From: Swanson, Greg
Sent: Tuesday, February 06, 2001 3:08 PM
To: Craig Bryson; Doug Wells; Kenneth Swaim; Lisa Hediger; Marcus Gregg; Pravin Aggarwal; Preston McGill; Sam Russell; Steve Androlake; Terry Hamm
Cc: Holt, Dan; Spanyer, Karen; McConnaughey, Paul; Cash, Steve
Subject: RSRM RRC Issues

SUBJECT: Thiokol Fracture Control Board Response to Questions
Raised by MSFC Fracture Control Board/Others Regarding Relative
Radius of Curvature

Main Landing Gear Wheel Tie Bolt Hole Corrosion

Tie Bolt Hole Corrosion

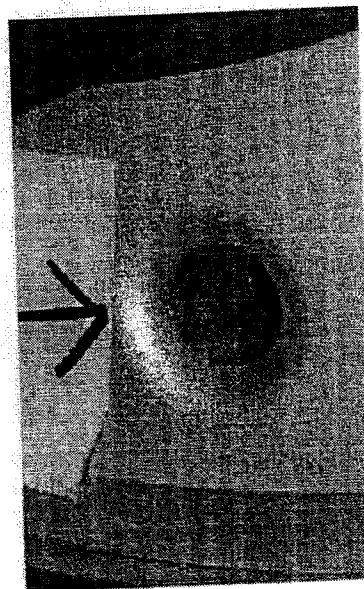
- Plan to rework surfaces to remove corrosion which will determine actual depth (*They took 0.010" off & some corrosion still exists*)

- Corrosion can be the initiation of a fatigue crack
 - Expect to find worst corrosion depth is $< .030$ inch fracture analysis flaw size
 - Visual approx 0.020 deep, Rework will determine actual depth
- Then worst corrosion will still have full fracture life
 - Minimum of 6 Landings
- Need to remove corrosion and blend area smooth
 - Corrosion will continue to grow
 - Need to know true depth of corrosion pits
- Goodrich may make a second trip to KSC (post STS-108) to Review real time processing at the wheel and tire shop if needed to complete root cause investigation
- PRT to review/recommend future corrosion preventative options
